**MINUTES of the duly convened Ordinary Meeting of The Hills Shire Council held in the Council Chambers on 28 August 2018**

# SHOWGROUND STATION PRECINCT - DRAFT DEVELOPMENT CONTROL PLAN, CONTRIBUTIONS PLAN AND PUBLIC DOMAIN PLAN (FP223)

The purpose of this report is to consider the outcomes of the exhibition of the draft development control plan, draft contributions plan and draft public domain plan for the Showground Precinct.

**Figure 4**  
Kathleen Avenue and Belvedere Avenue (Site Specific Request)

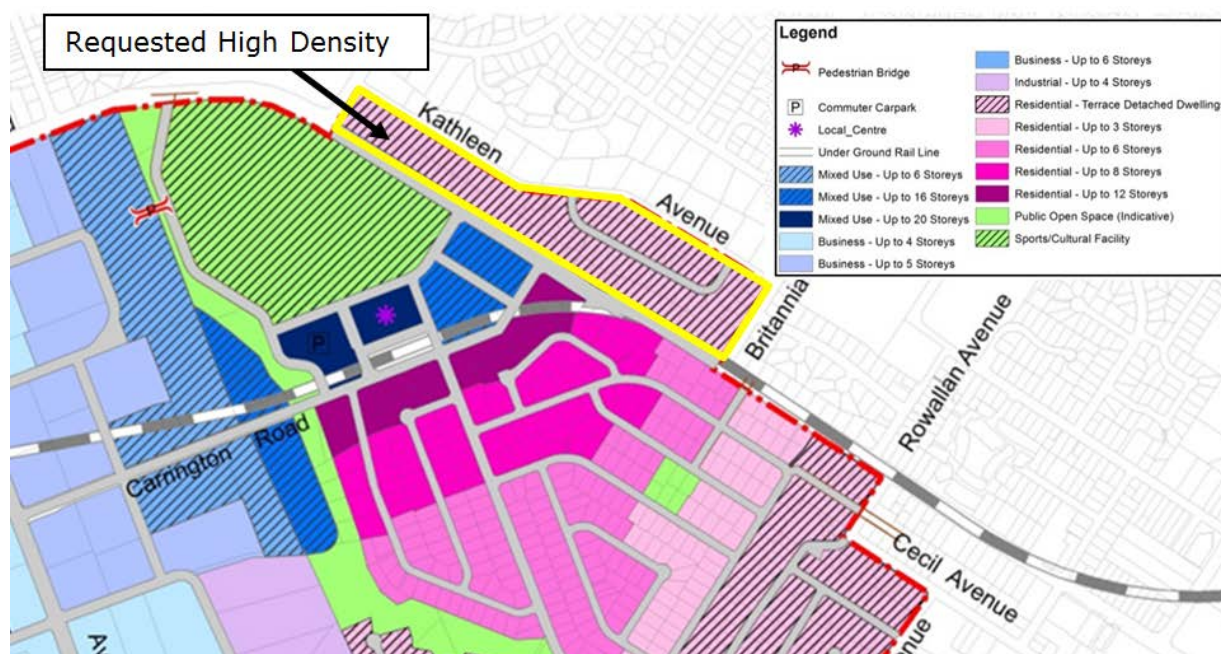
Submission requested the identification of land north of Showground Road for higher density development. Concern was raised that this land falls within the walkable catchment of the Showground Station. Comments also identified the proposed redevelopment of this area to accommodate "terrace style housing" would be economically unviable for a developer due to the land and build costs.

The State Government rezoned land within the Showground Precinct on 15 December 2017. The land zone, height of building, floor space ratio and incentive floor space ratio are LEP standards and provisions set within LEP and not matters regulated by the DCP, which provides additional guidance for future development. The development control plan, contribution plan (infrastructure plan) and public domain plan have been prepared by Council to support the rezoning of the Precinct, not to change the zoning or permissibility of uses.

Should a landowner seek to change the current zone, there is a separate mechanism available through lodgement of a planning proposal that allows for consideration of the capacity to support additional growth, including infrastructure demand. However, given that this process has recently been undertaken for the entire Precinct it is unlikely to be supported.

**Figure 5**  
Riparian Corridor Interface Areas

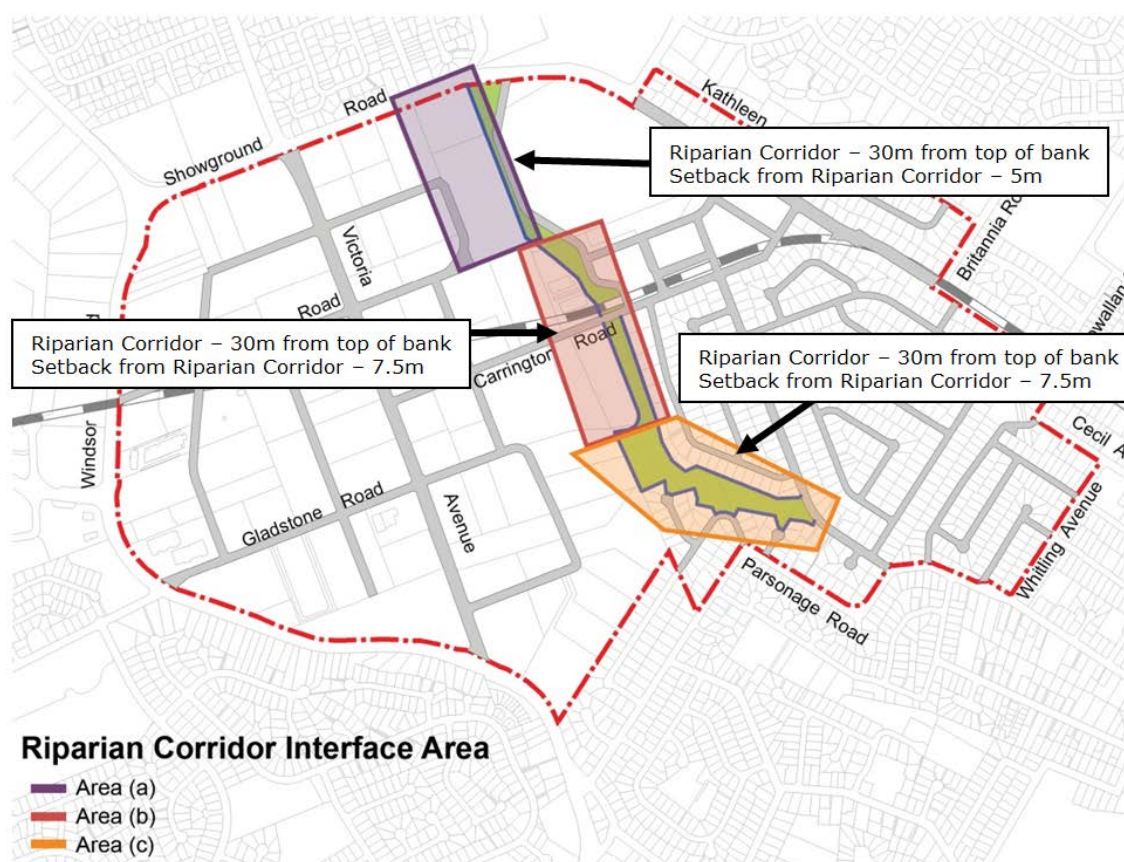
The draft DCP required the following riparian corridor widths and setback distances to the riparian corridor.

However the Office of Water Guideline for Riparian Corridor Distances specifies a 10m riparian zone (on each side of the creek) for 1<sup>st</sup> order streams and 20m riparian zone (on each side of the creek) for 2nd order streams. It is noted that Areas (a) and (b) are 2<sup>nd</sup> order streams and Area (c) is a 1<sup>st</sup> order stream. Accordingly, it will be necessary to amend the draft DCP to update the controls by reducing the riparian corridor distances to the following:

An amendment to the riparian corridor map in the public domain plan would also be required to reflect the updated riparian corridor distances within the DCP.

**Figure 8**

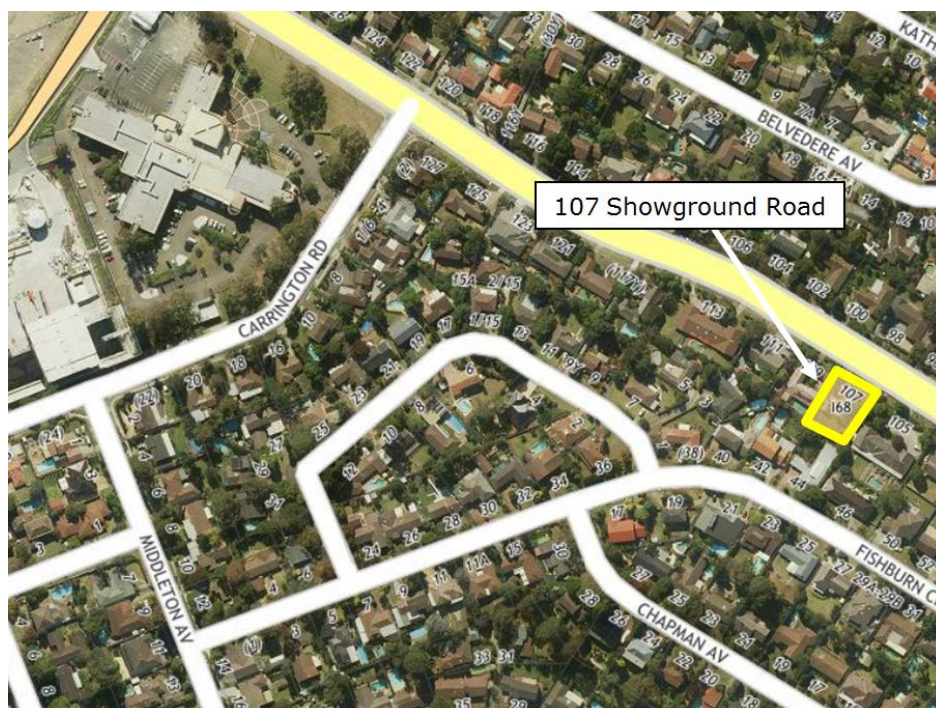
Concern regarding the heritage controls within the DCP with respect to their application to 107 Showground Road. The control requires the built form on adjoining sites that interface with the heritage item to be 10m or 3 storeys (whichever is less). The submitter has suggested that the height should be 4 storeys (consistent with the GML Assessment which formed part of the exhibition of the Planned Precincts. It was further noted that this is restriction would be inconsistent with the intended height of 6 storeys within the area.

Development adjoining the heritage site will be required to provide a transition of building height and reduce the impact of future built form on the significance of the heritage item. This does not mean that development sites adjoining the item are capped at a reduced height over the entirety of their site. Rather the building elements that interface with the heritage item would be limited. In this location a podium element would be required whereby the upper levels are stepped in. Nevertheless it is considered reasonable that the draft DCP be amended to increase this height from '3 storeys or 10m (whichever is lesser)' to '4 storeys or 13m (whichever is lesser)'. So long as the heritage curtilage of the property is maintained and adjoining buildings provide a transition of building height, the significance of the item should be appropriately maintained.

**Figure 10**  
Exhibited rear laneway widths

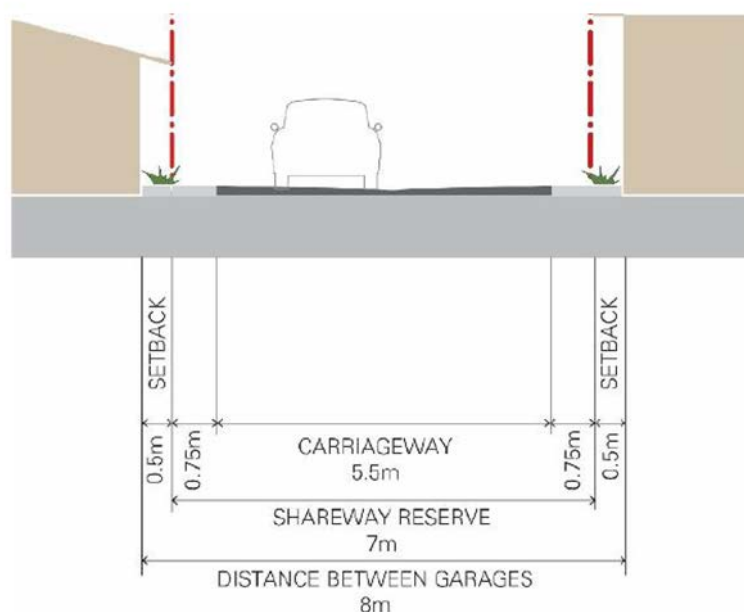
Submission authors further noted that there was some inconsistency in the rear laneway dimensions within the DCP and potential conflicts such as waste collection. The rear lane controls that were exhibited reflected the rear lane specifications within the development controls plans for the Growth Centre Precincts. These controls require a 5.5m carriageway and a 0.75m verge width on either side, resulting in a total rear laneway reservation width of 7m. The section showing the exhibited controls are included in the following figure.

It has become apparent within these precincts that the rear laneway widths are insufficient and do not provide waste collection trucks (side arm vehicles) with adequate space to manoeuvre. Whilst parking restrictions would apply to rear laneways, it is likely that instances will occur where a car will park along the carriageway, despite the restriction. In order to account for this, carriageways need to be of a sufficient width (at least 6 metres) to enable a waste collection truck to pass any car that may be parked on the laneway. Furthermore, bins would need to be placed on, and collected from, the verge space. However, even with a 0.5 metre setback, having a 0.75m verge space will not provide

In order to ensure that it is clear to future occupants on where the bins are to be located, it is proposed that a new control be included within the DCP to provide a concrete bin pad on the kerb adjacent to the driveway. This will ensure that bins are appropriately located for collection. It is also proposed that a new control be included within the DCP to require swept path analysis for heavy rigid vehicles. This will ensure that collection trucks will be able to safely enter, travel along and exit the rear laneway without damaging any structure or vegetation within the road verge. It is proposed that the following be included within the DCP:

To assist interpretation and application of the control, it is also proposed that the rear laneway section and plan view figure be updated to reflect the above changes.

**Figure 11**  
Deferred Area

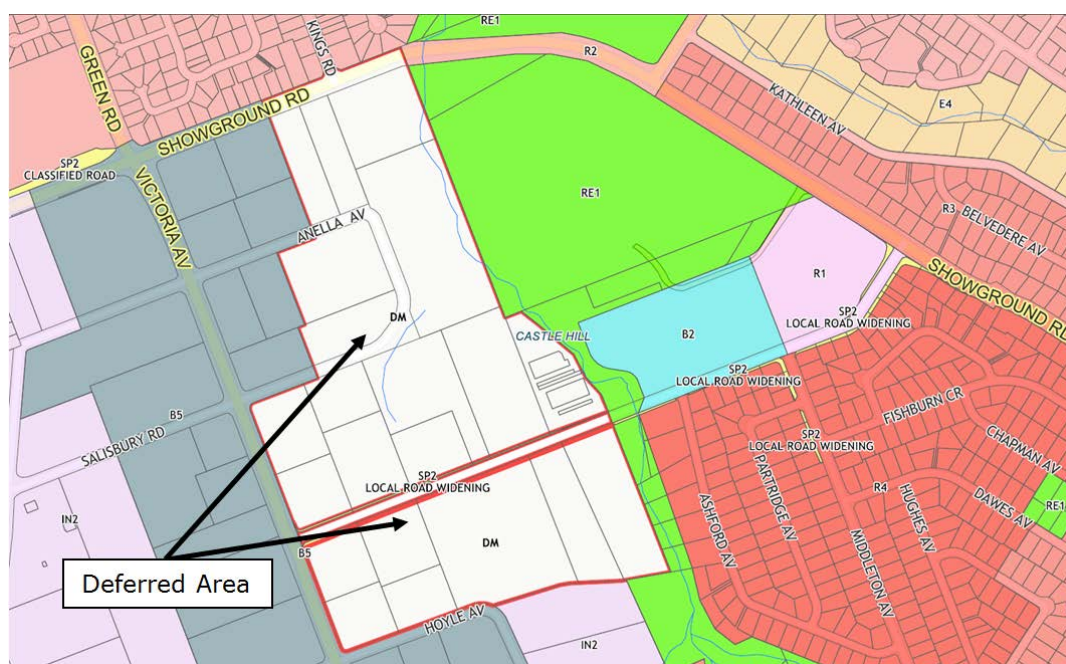
Concern was raised in relation to the application of the DCP, contribution plan and public domain plan to the deferred area (with specific reference to 3 Hoyle Avenue). The inconsistency was considered to be confusing. Furthermore the DCP identified road and pedestrian links through sites that have not as yet been rezoned. Submissions also noted that the draft DCP proposes public roads and pedestrian connections through various properties which, without any uplift in zoning, would create an acquisition liability.

The purpose of deferring this area was to allow for further master planning (Cattai Creek Master Plan Process) of this area which is currently being led by the Department of Planning and Environment. This master planning process will articulate the intended built form, land uses and public infrastructure required to support future development. The master plan will also articulate the required revitalisation and rehabilitation works along the Cattai Creek riparian corridor.

As the gazetted maps identify this area as a 'Deferred Area' it is recommended that the draft development control plan, contributions plan and public domain plan be amended to also identify this land as a 'Deferred Area'. It will be expected that any future LEP amendment resulting from the Cattai Creek West Master Planning Process will also involve an amendment to the draft DCP, contribution plan and public domain plan for the Precinct.

**Figure 12**  
6-8 Hudson Avenue

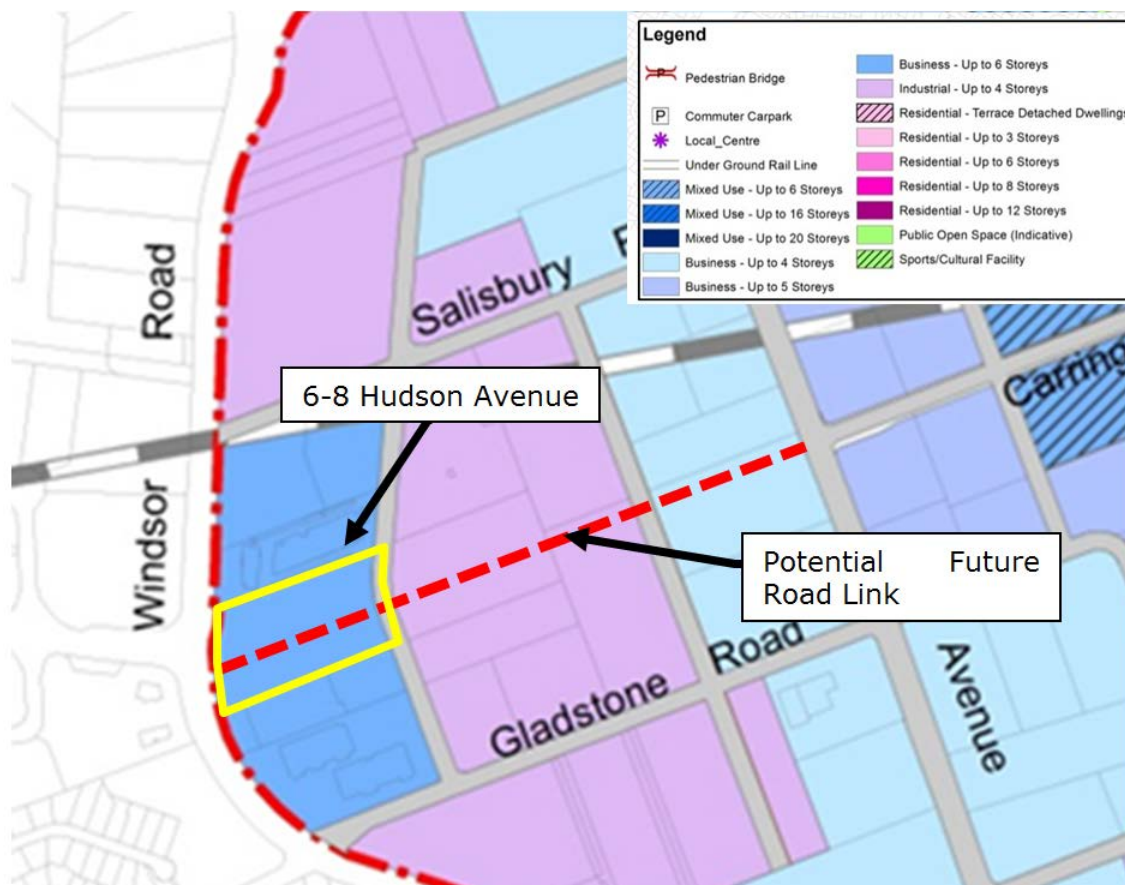
Submission lodged on behalf of the owner of 6-8 Hudson Avenue has raised concern with respect to the proposed 15m setback to the future road link extending from Norwest Boulevard to Victoria Avenue as this will severely restrict the potential footprint of future development. The location of 6-8 Hudson Avenue on the draft Structure is included below.

The site is located within a pocket of land, bound by Windsor Road, Gladstone Road, Hudson Avenue and Salisbury Road, which was rezoned to B6 Enterprise Corridor, and applied a floor space ratio of 2.3:1 and a height of buildings requirement of 27m. The DCP anticipates that this land will accommodate higher density commercial/ business uses in a built form of around 6 storeys. The indicative street network and hierarchy plan also identifies a potential future road link connecting the intersection of Windsor Road / Norwest Boulevard and Carrington Road / Victoria Avenue.

With respect to the employment area, the exhibited DCP retained the existing 15m setbacks to employment roads. Coupled with the road reservation for the new road link the 15m setback would result in building platforms not suitable for a high density commercial building. In order to facilitate the future road link, the submission author has suggested 5m setback to the new road. This would both allow for a suitable building platform on either side of the future road link, and would also provide a continuation of the 5m setback which is anticipated along Carrington Road.
